**PMD DRIVER RELOCATION KIT
1994-2000 Chevy 6.5L Diesel Trucks**

Part# 1036520

PARTS BULLETIN

SUBJECT: NEW PUMP MOUNTED DRIVER (PMD) AND WIRING HARNESS FOR DS PUMP MODELS

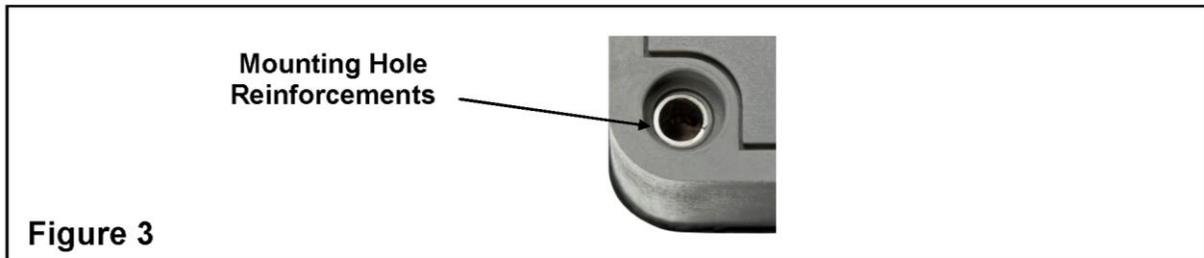
- Gold plated electrical connection pins and wiring harness connector terminals to improve conductivity and help to reduce corrosion fretting (Figure 1).

- The shape of the PMD connector, wiring harness terminal and calibration resistor were changed (Figure 2) to prevent intermixing of "plated" and "non-plated" components (dissimilar metals).

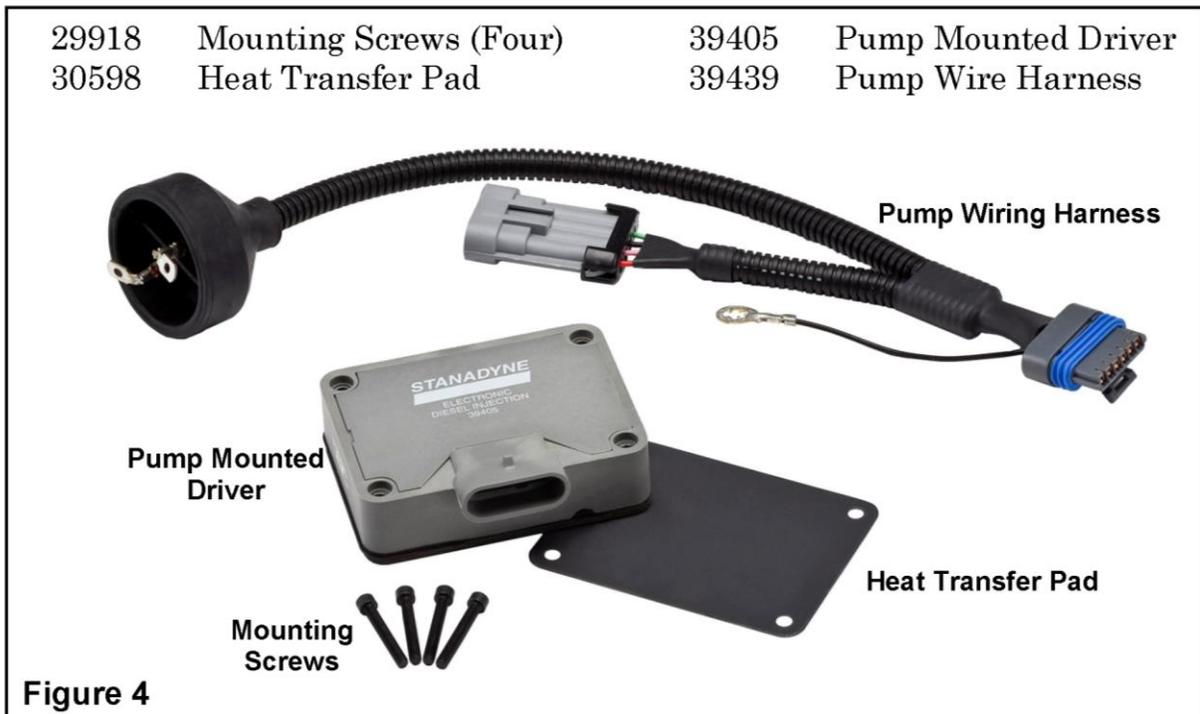
- Re-enforced mounting holes eliminate internal circuit board deformation during installation and improve mounting torque retention (Figure 3).

The 39405 PMD is not available separately, but is packaged together with a wiring harness and associated mounting hardware in the P/N 35976 PMD and Harness Kit which includes the following (Figure 4):
